# HISTORIC AND DESIGN REVIEW COMMISSION

April 05, 2023

**HDRC CASE NO:** 2023-120  
**ADDRESS:** Multiple structures throughout the La Villita Historic District; Buildings 1, 2, 3, 4, 5, 6, 7, 8, 10, 11, 12, 13, 14, 16, 17, 18, 20, 21, 22, 23, 24, and 29  
**LEGAL DESCRIPTION:** Public Property  
**ZONING:** D, H, RIO-3  
**CITY COUNCIL DIST.:** 1  
**DISTRICT:** La Villita Historic District  
**APPLICANT:** City of San Antonio  
**OWNER:** CITY OF SAN ANTONIO  
**TYPE OF WORK:** Review of impacts to historic structures by HVAC upgrades, exterior modifications, door replacement, vent installations  
**APPLICATION RECEIVED:** January 05, 2023  
**60-DAY REVIEW:** Not applicable due to City Council Emergency Orders  
**CASE MANAGER:** Edward Hall  
**REQUEST:**

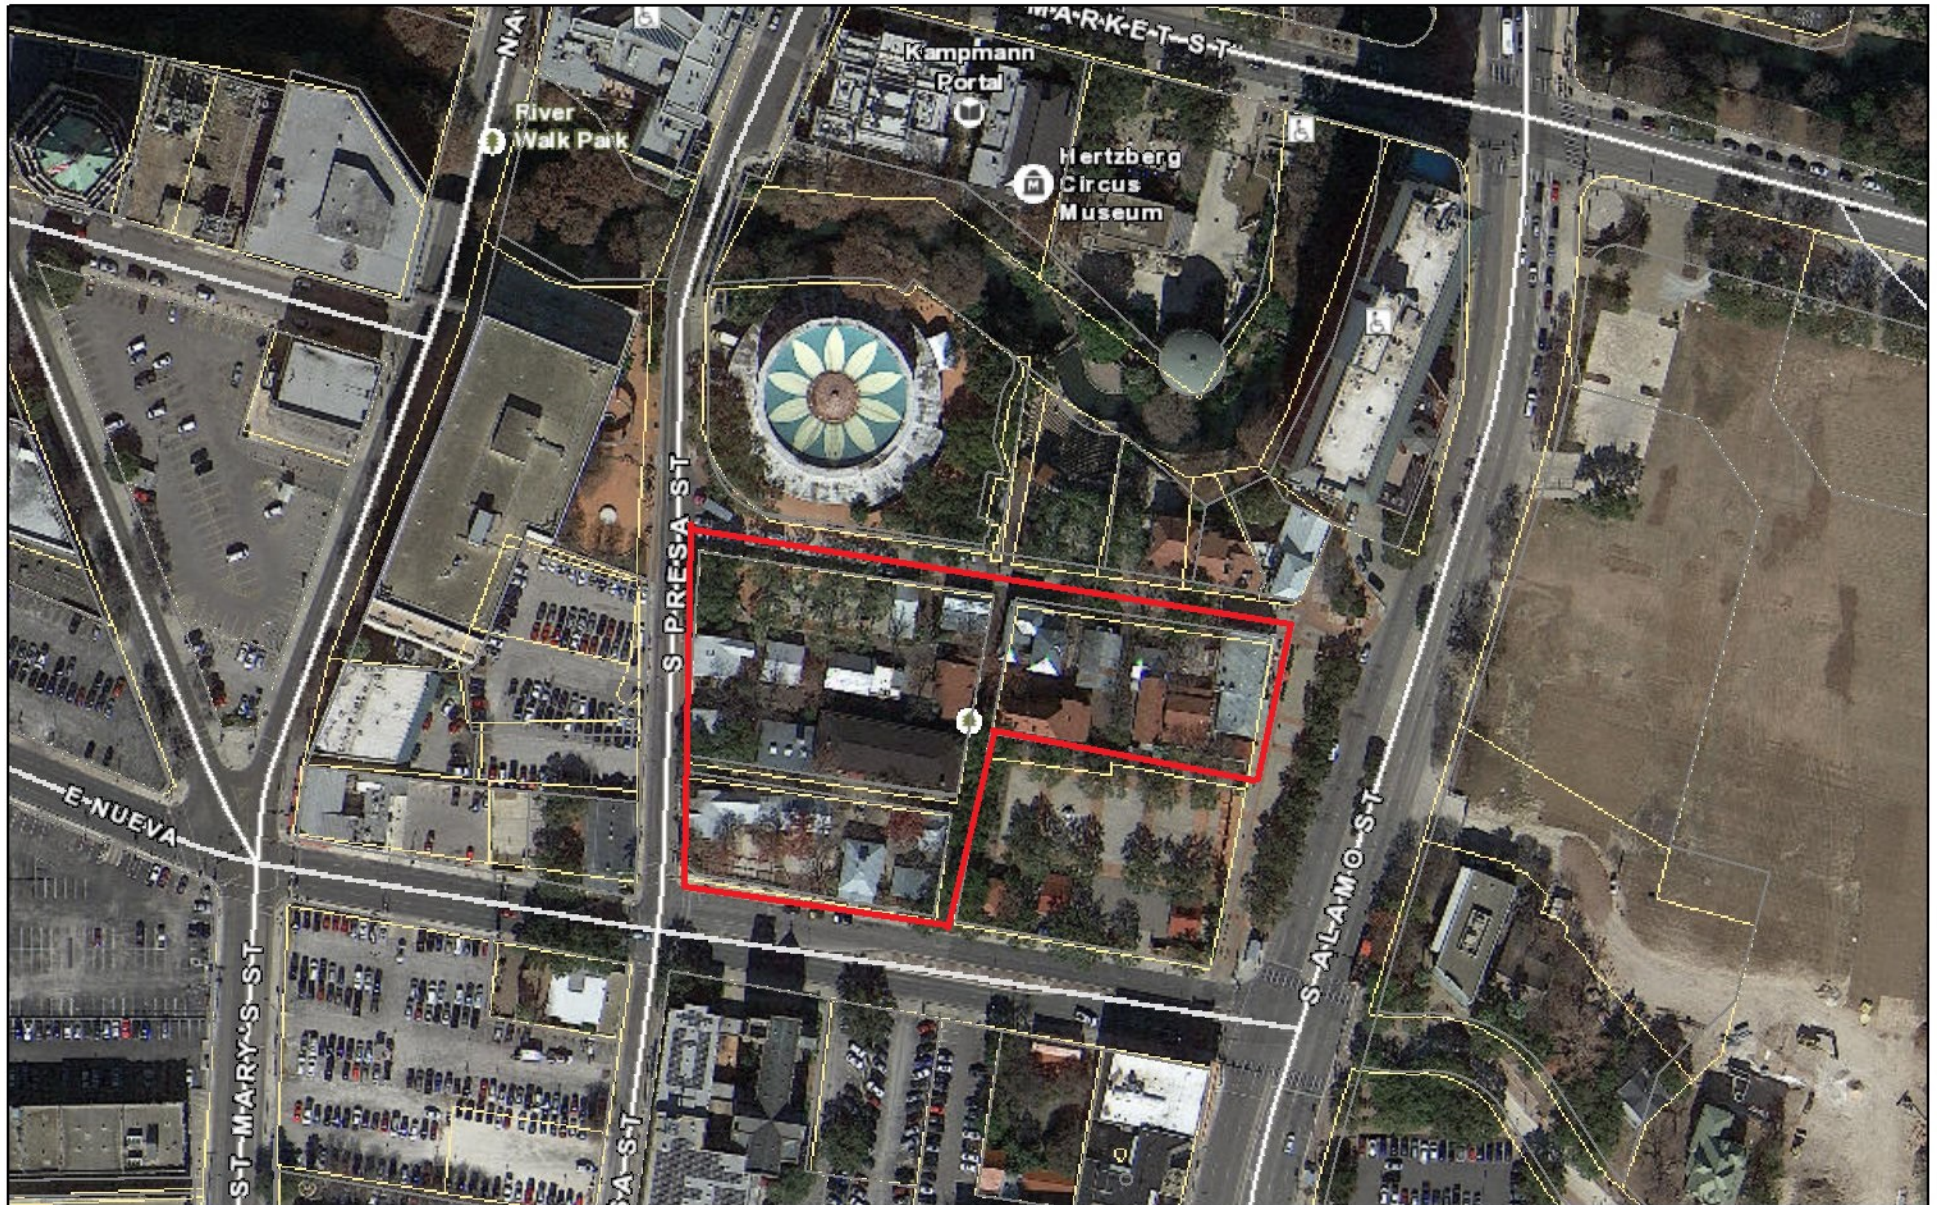
- d. DOOR REPLACEMENT – The applicant has proposed to replace existing wood doors at Building 16 with new wood doors. Both doors are utility access doors and are not located at pedestrian entrances. Staff finds that doors that are beyond repair are eligible for administrative approval; however, the profile of the replacement doors should match the existing or be comparable with existing, historic doors.

Staff recommends approval of the proposed exterior modifications to historic structures within the La Villita Historic District associated with the upgrade and installation of HVAC equipment and limited rehabilitation, repair and replacement scopes of work with the following stipulations:
